MONTGOMERY COUNTY HISTORIC PRESERVATION COMMISSION
STAFF REPORT

Address:	5511 Lambeth Rd., Bethesda	Meeting Date:	7/28/2021
Resource:	Contributing Resource (Greenwich Forest Historic District)	Report Date:	7/21/2021
Applicant:	Lauren Breitenother and Jeffrey Clark	Public Notice:	7/14/2021
Review:	HAWP	Staff:	Dan Bruechert
Case Number:	956017	Tax Credit:	N/A
PROPOSAL:	Window Replacement

Figure 1: 5511 Lambeth Rd., Bethesda.

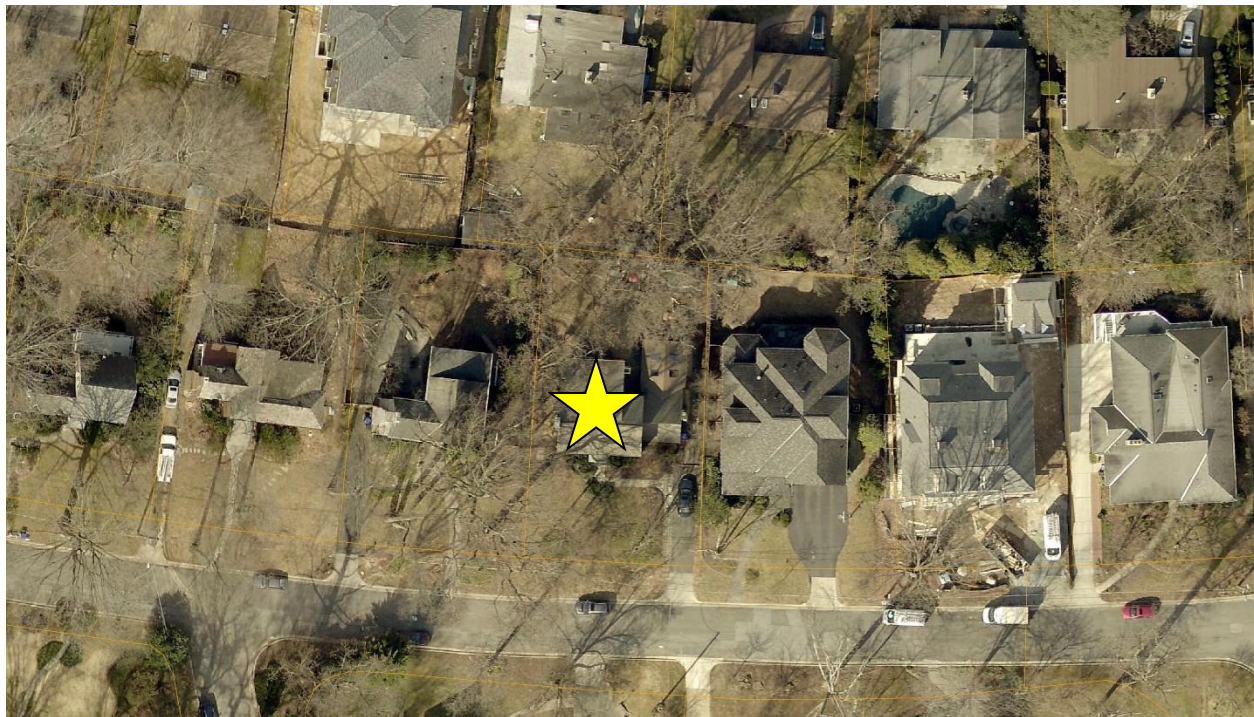
Staff would be remiss not to mention that these windows appear to be traditionally constructed wood windows that can be repaired. The costs associated with repairing these windows are eligible for the County’s Historic Preservation Tax Credit, which is a 25% credit applied to the property tax bill. After the window repair and a properly installed storm window (which are also eligible for the tax credit), the windows would be as efficient as the proposed replacements with the added benefit that the windows could be repaired in another 80 years. The window repair would not require a HAWP and new storm windows could be reviewed and approved at the Staff level.

Figure 2: window section drawings from Marvin.

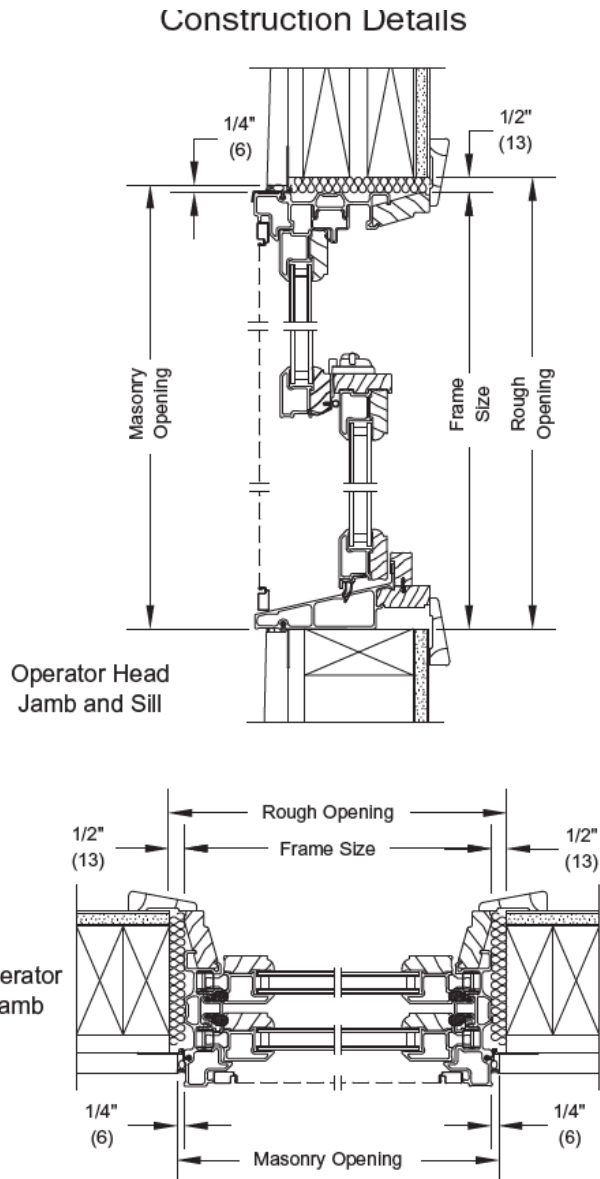
Staff finds the exterior profiles of the proposed windows are thinner than a wood or aluminum-clad wood window, however, the *Greenwich Forest Design Guidelines* state that replacement windows are acceptable provided the replacements are compatible with the ‘architectural style’ of the house. This is not a window Staff would support for Contributing resources in most other districts, but the windows match the size, configuration, and operation of the existing windows and Staff finds they match the style of the house and recommends approval.

Staff recommends that the Commission **approve** the HAWP application under the Criteria for Issuance in Chapter 24A-8(b)(1), (2), and (d), having found that the proposal, as modified by the condition, is consistent with the *Greenwich Forest Historic District Guidelines* identified above, and therefore will not substantially alter the exterior features of the historic resource and is compatible in character with the district and the purposes of Chapter 24A;
